Inspection Report

Report Date: June 7, 2005

Mine Name: Torrey Buff

Permit number: S/055/022

Photo 1. The circled area is where we agreed some material should be pulled down from above to "soften" the highwall.

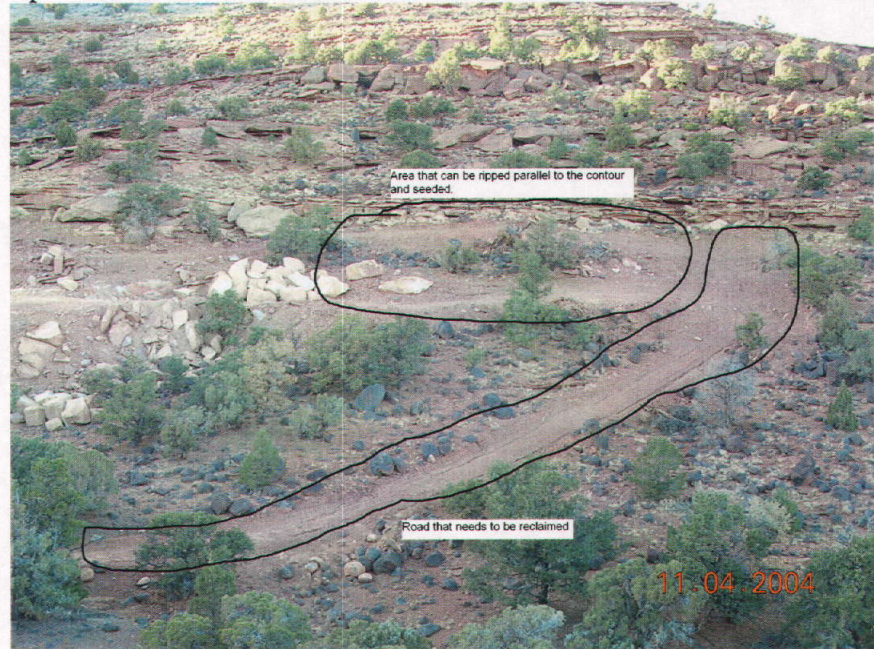
3. Photo 1 shows a portion of the northwest part of the quarry. Some reclamation grading has been done in this area since the picture was taken. The photo shows an area above the highwall that needs to be "softened" by bringing down some of the material from above.
